**PLANNING BOARD REGULAR AND REORGANIZATION JANUARY 5 2021 AGENDA
CONDUCTED WITH ZOOM
JANUARY 05, 2021 7:00 PM – TUESDAY**

15. UNION AVENUE - SEPE - AFFORDABLE HOUSING APPLICATION

**Re: Manasquan Planning Board Application MSPB #R-1170
Preliminary and Final Major Site Plan Approval w/ Bulk Variance (“Application”)
33, 33 1/2 - 39 Union Avenue, Manasquan, New Jersey
Block 66.02, Lot 31.01 (“Property”)**

**RE: SITE PLAN FOR UNION AVENUE 33, LLC
BLOCK 66.02, LOT 31.01
MANASQUAN BOROUGH PLANNING BOARD
OUR FILE # MQSP10105**

MAJOR SITE PLAN
 TAX BLOCK 66.02
 LOTS 31.01
 BOROUGH OF MANASQUAN
 MONMOUTH COUNTY, NEW JERSEY

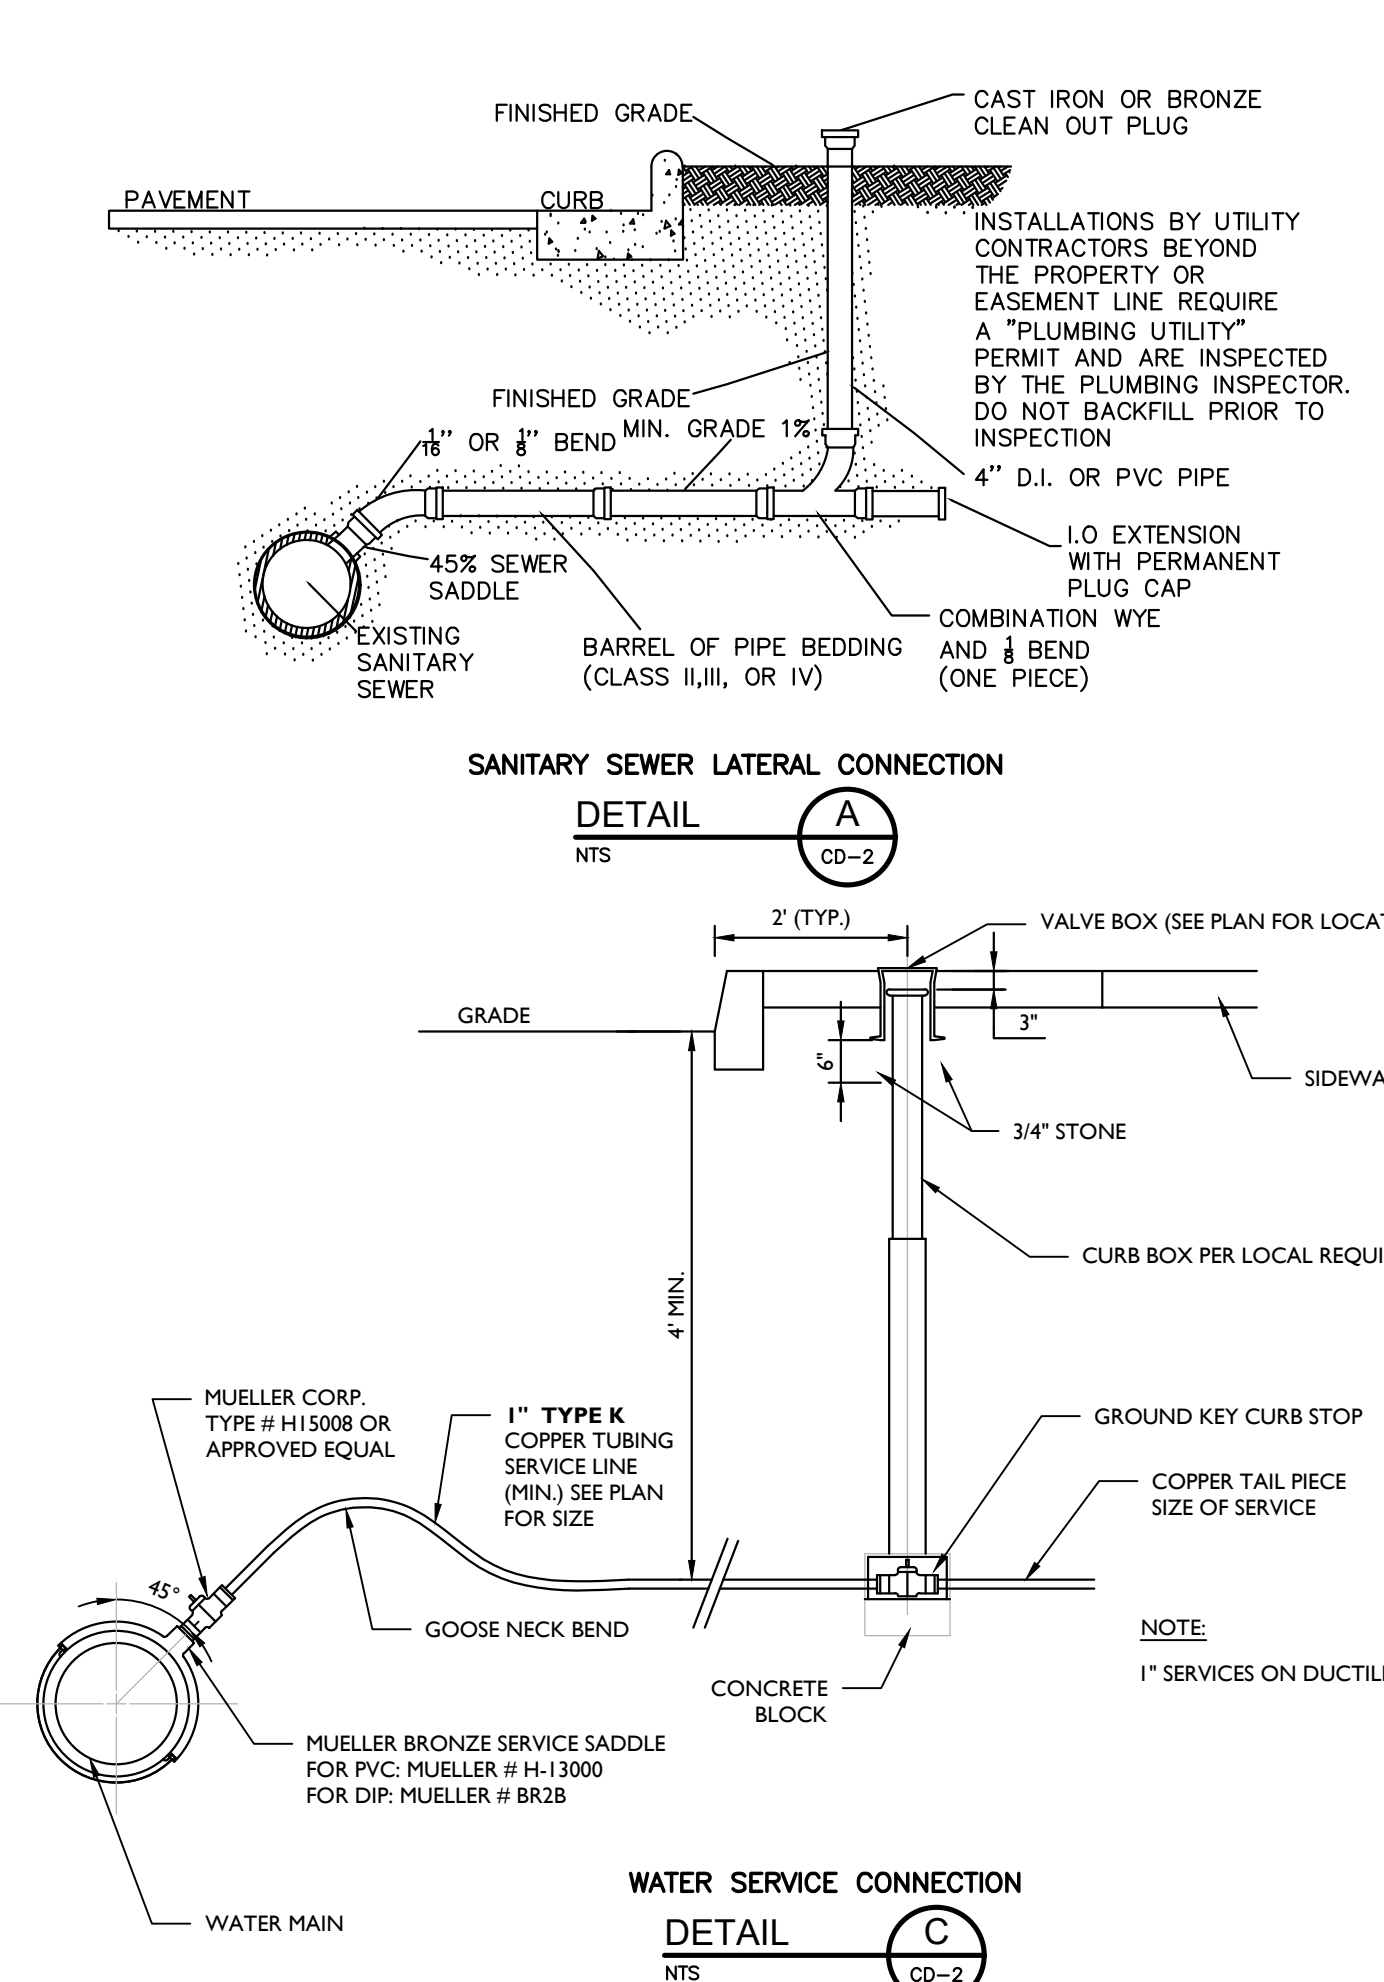
29. *Any sidewalk must be replaced as necessary on Union Avenue **The plans have been revised to show curb and sidewalk replacement on Union Avenue (sheet CD-1).***
